NSW GOVERNMENT
Department of Planning

ASSESSMENT REPORT

Moolarben Coal Mine Section 75W Modification

Figure 3: Proposed Rail Loop Design

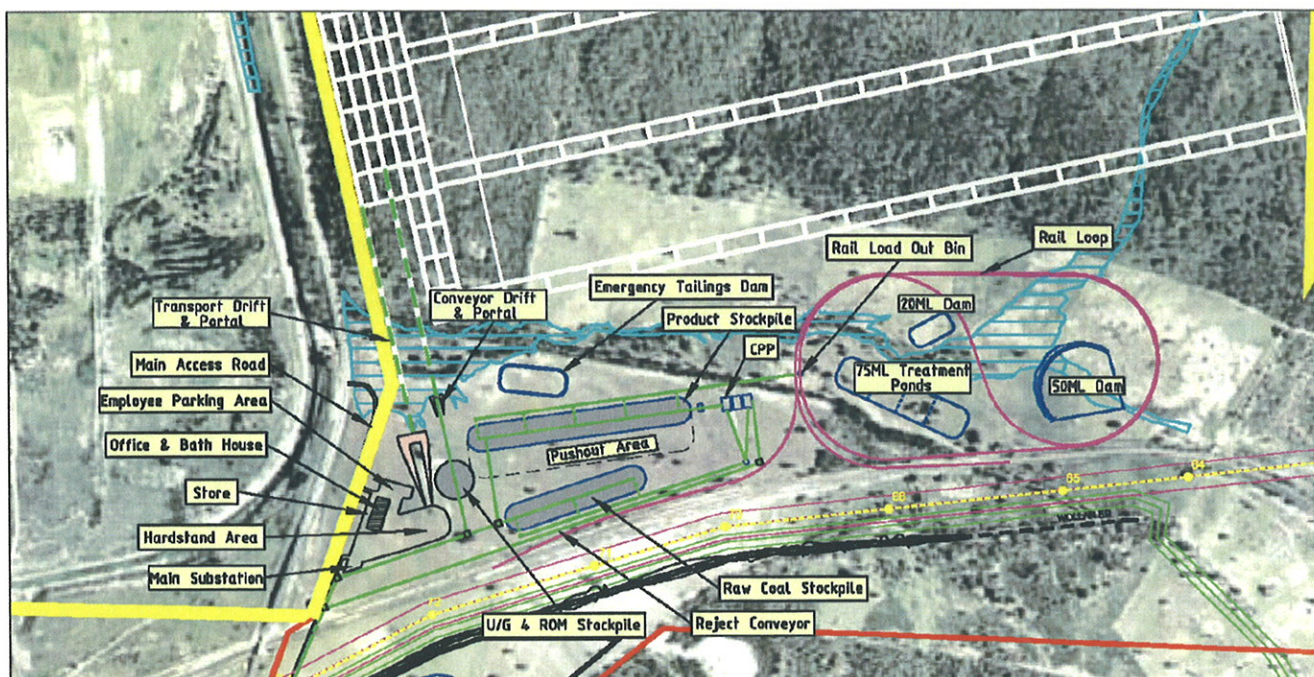
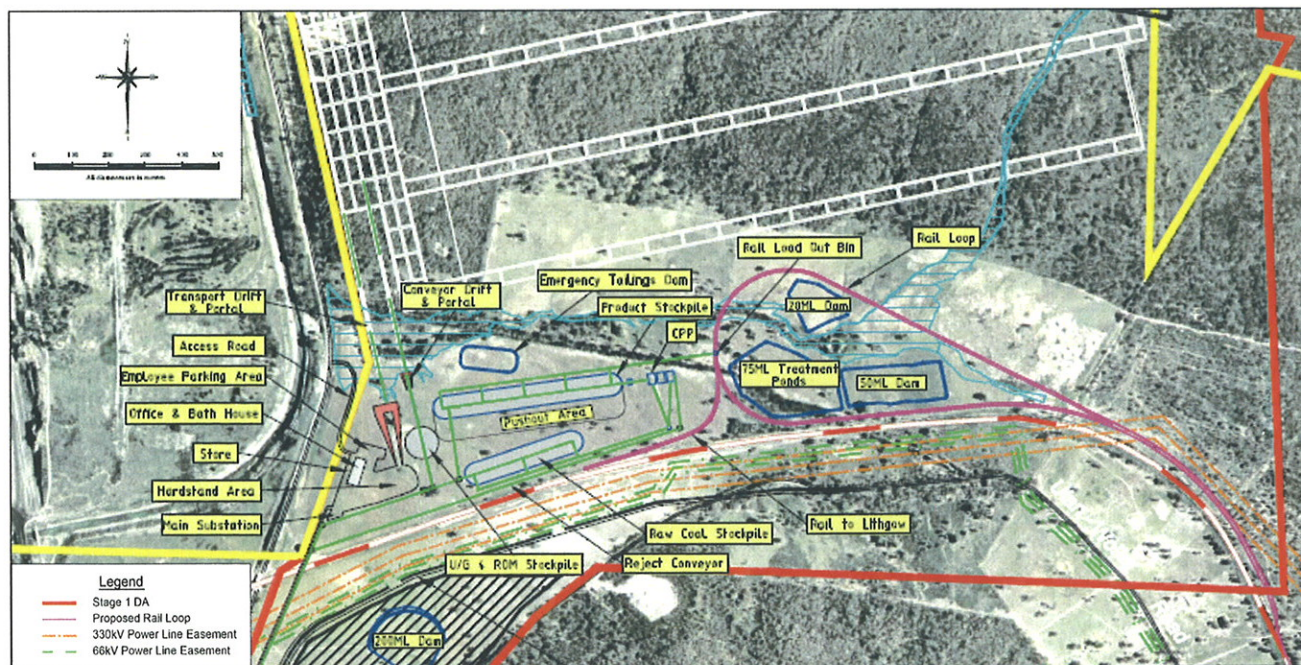
While this large proposal is being assessed, Moolarben is also seeking to modify the approval to allow the approved rail loop to be reconfigured (see Figures 2 and 3).

The modified rail loop design has been enabled by Moolarben's recent acquisition of several properties to the west of the rail loop.

It has several advantages over the original design, in that it:

- reduces the footprint disturbance area by approximately 1.3 hectares (ha);
- provides better rail loading conditions because it is on a more level gradient;
- reduces capital and operating costs for Moolarben (estimated cost savings of approximately \$0.75 million due a 500m shorter track distance).

The design of the modified rail loop would also require some minor changes to the shape and location of an approved 50 Megalitre (ML) groundwater storage dam and an approved 75ML groundwater treatment pond, both situated within the balloon loop. The function and capacity of both water facilities would remain unchanged.

Figure 4: Site Vegetation

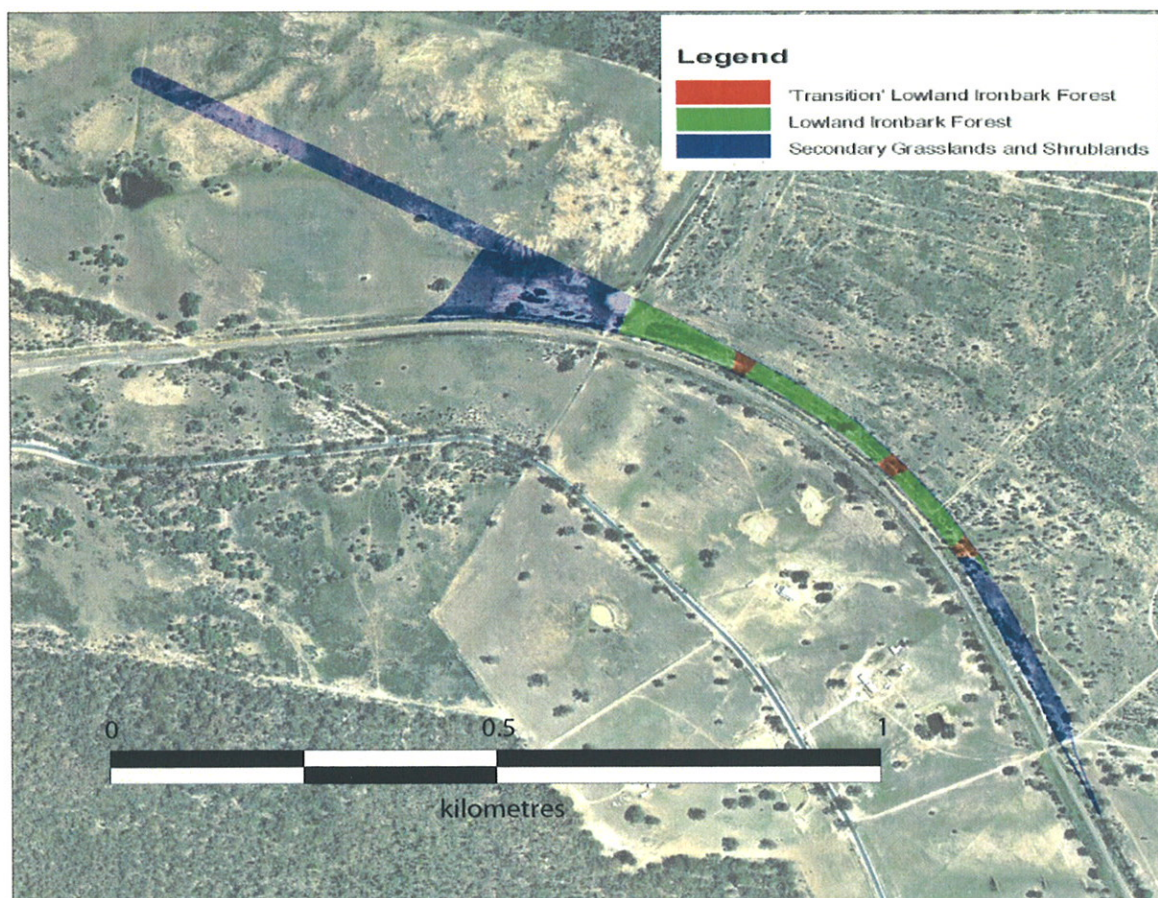
An Ecological Assessment was conducted by Ecovision Consulting Pty Ltd. The assessment found that the proposal would result in the clearing of 6 ha of native vegetation, comprising 1.7 ha of intact Lowland Ironbark Forest and 4.3 ha of Secondary Grasslands and Shrublands (see Figure 4). The Lowland Ironbark Forest contains approximately 0.2 ha of vegetation which is considered to be White Box Yellow Box Blackely's Redgum Woodland (WBYBBRW) and Derived Grasslands EEC/Critically Endangered Ecological Community (CEEC).

Moolarben has made a series of commitments to avoid, manage and mitigate these impacts. Most notably, the company proposes to compensate for the loss of additional EEC/CEEC by increasing the approved offset area from 130 ha to 135 ha and to revegetate an additional 6 ha of cleared land on the Red Hills property and adjoining lands.

Consequently, the Department has recommended modification of Condition 41(a) to add 5 ha to the required 130 hectares of WBYBBRW and modification of Condition 42(b) to add 6 ha to the required 143 ha of land to be revegetated. The Department is satisfied that the Rehabilitation & Offset Management Plan required under the existing conditions of approval would provide adequate long-term management of these areas.
